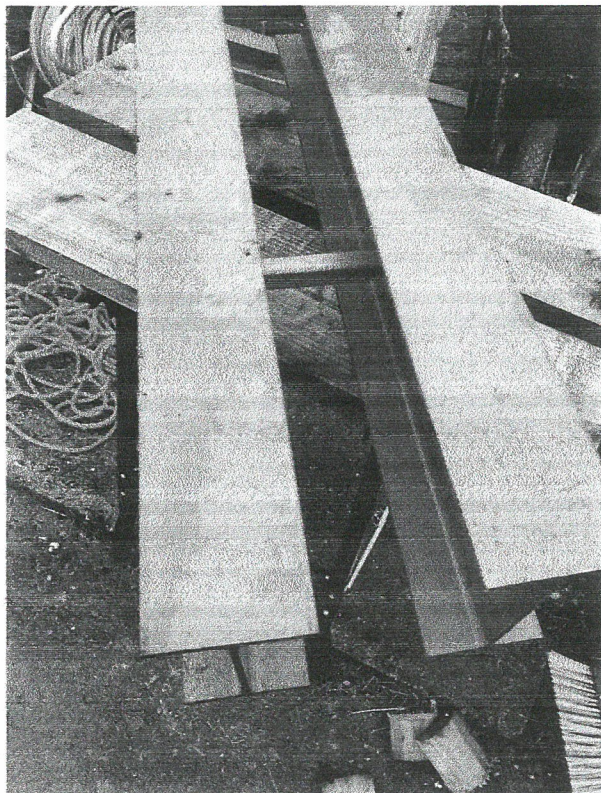
Listed Building Consent has not been sought for the removal or alteration of any of the existing walls within the building. Can you confirm that you instructed the removal or alteration of the following walls and provide any evidence you may hold of the wall construction in the following location Wall removed between GF4 and GF5

Yes Partial removal Twin Steels inserted
